Enclosure 7

**Draft RAI Responses to RAIs NP-2.2-1, NP-2.2-2
and EP-X
(Non-Proprietary Version)**

Safety Analysis Report (SAR), Chapter 2, "Site Characteristics"**RAI NP-2.2-1:**

Figure 2-39
Low Altitude Air Routes Passing Near the Site

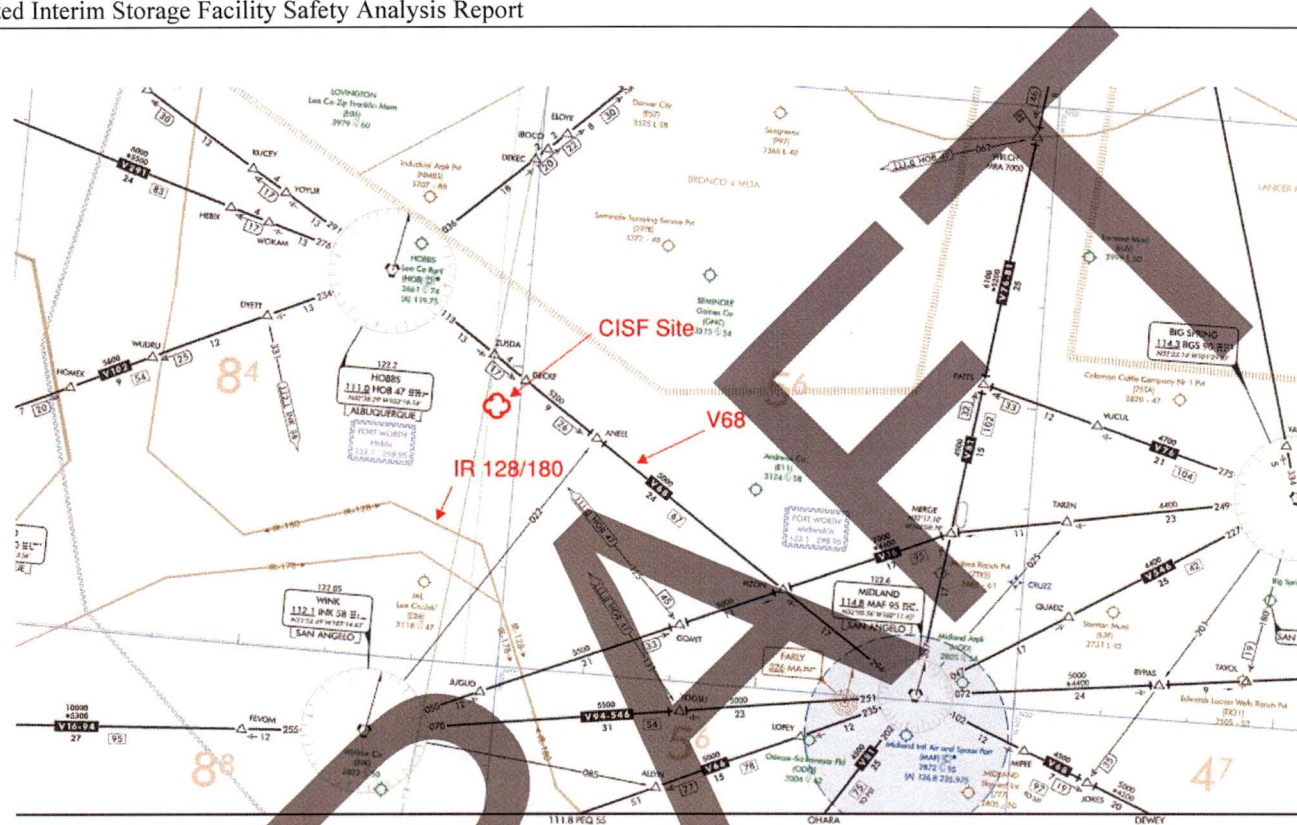
Provide an evaluation and aircraft crash probability impact analysis of airway V68, which passes nearby the proposed WCS CISF, in accordance with guidance and acceptance criteria provided in NUREG-1567, Section 2.4.2.

During the NRC staff's review of the information presented in WCS CISF SAR Section 2.2, "Nearby Industrial, Transportation and Military Facilities," the NRC staff identified an airway V68 passing nearby the proposed WCS CISF, which is not addressed by ISP. The closest airport identified is the Lea County Airport, which is 18 miles from the WCS CISF. Provide an analysis and evaluation of airway V68 and incorporate the changes, as appropriate in the application.

ISP performed an aircraft hazards evaluation for the WCS CISF and added a summary of that evaluation in new SAR Section 2.2.1, Aircraft Hazard Evaluation. The evaluation uses the guidance in NUREG-0800. The evaluation results, based on site-specific flight information and nearby airport locations, indicate that the annual probability of aircraft crash at the WCS CISF is approximately $3.81\text{E-}7$. Using an alternative conservative approach (i.e., that all flights pass over the site), the annual probability of occurrence is computed to be less than $7.38\text{E-}7$. Both probabilities are below the NRC annual probability of occurrence threshold of $1.0\text{E-}6$ for aircraft crash as articulated in NRC Memorandum and Order CLI-01-22. On this basis, ISP concludes that aircraft crash presents low risk to public health and safety and is therefore not necessary to be included as a design basis consideration. SAR Section 2.8 References has also been updated to include the new references added in Section 2.2.1. Also included with the RAI response is a copy of the Proprietary Aircraft Hazard Evaluation Report which forms the basis for SAR Section 2.2.1.

- V68 is a low-altitude east-west route (113° out of Lea County Regional Airport N32°38.29' W103.16.16' toward Midland Airpark Airport N32°00.56' W102°11.42'). Its centerline passes approximately 4 miles from the plant site and has a width of 9.21 miles (8 nautical miles).

Figure 2-3
Proposed WCS CISF 5-mile Radius

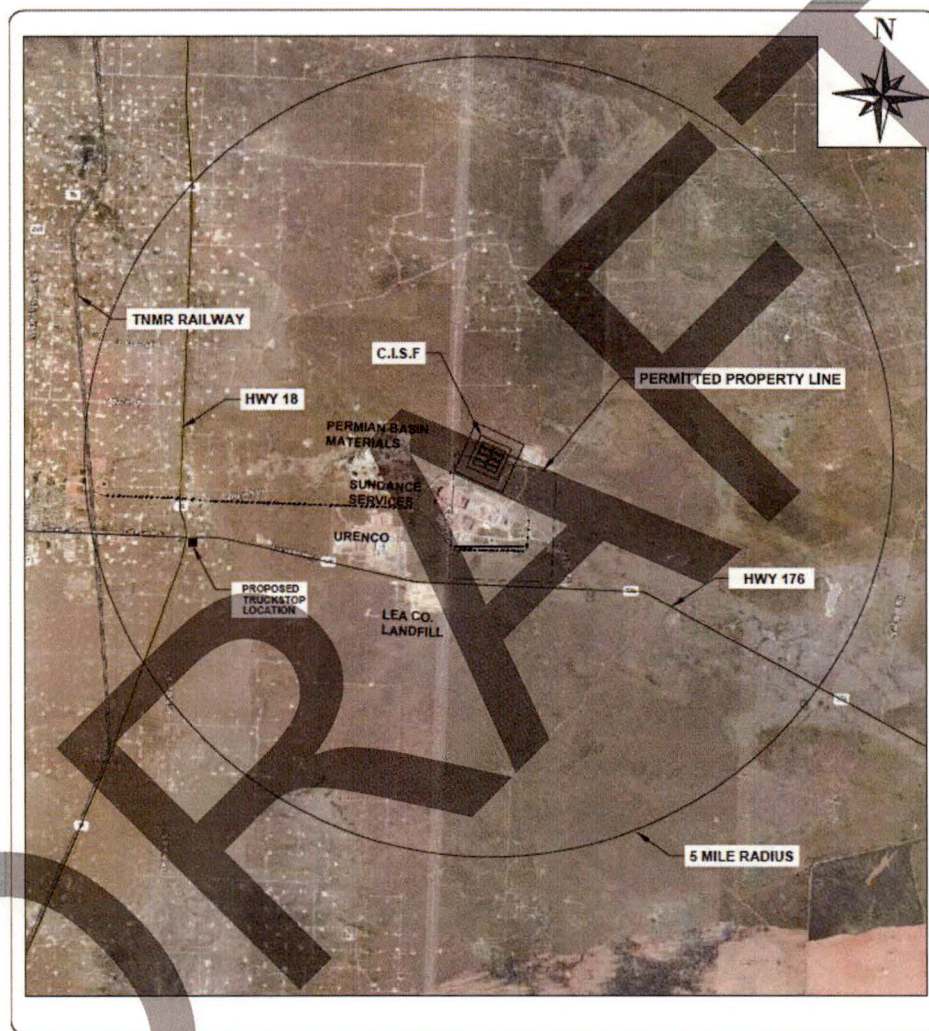
Provide the locations of nearby industrial, transportation, military, and nuclear installations. Describe potential hazards to the proposed WCS CISF from activities or materials at those facilities in accordance with the guidance and acceptance criteria provided in NUREG-1567, Section 2.4.2.

During the NRC staff's review, the NRC staff determined that ISP identified nearby facilities, but did not provide potential impact evaluations of these facilities on the proposed WCS CISF. Specifically, ISP identified a railroad, but did not provide details on products/materials transported by rail; the distance of the rail line from the proposed facility; or the potential impacts (if any) on the proposed facility. ISP identified Texas State Highway 176, but not the shortest distance between the highway and the proposed facility. ISP stated oil industry pipelines are located near the facility in WCS CISF SAR Section 12.2.2, but did not provide details as to what materials are transported in the pipelines; the distance of the pipelines from the proposed facility; or the impacts of the pipelines on the proposed facility. Different materials can be transported through these pipelines and these different materials can pose different potential hazards to the site.

The Waste Control Specialists rail spur and loop exits the Texas & New Mexico Railway near Eunice, New Mexico as shown in updated Figure 2-3. This spur continues east until it reaches the existing Waste Control Specialists facility where it forms a loop around the facility. The rail side track to the WCS CISF will begin by connecting to the northwest side of the existing loop and terminate by re-connecting at the north side of the loop. This rail line is completely controlled by ISP joint venture member Waste Control Specialists and limited to approved Waste Control Specialists waste shipments and transport casks. Railcars carrying contents with the potential to adversely affect the WCS CISF will not be permitted on the Waste Control Specialists rail spur and loop. Fire and explosion precautions for the WCS CISF rail side track are discussed in Section 3.3.6 of the SAR.

Section 2.2 of the SAR is updated to include discussion of New Mexico State Highway 18, the Texas & New Mexico Railway, the Energy Transfer LP pipeline, the Love's travel stop, and reference to the evaluations discussed in Section 12.2.2. Figure 2-3 is updated to include facilities within a radius of 8-km (5-miles).
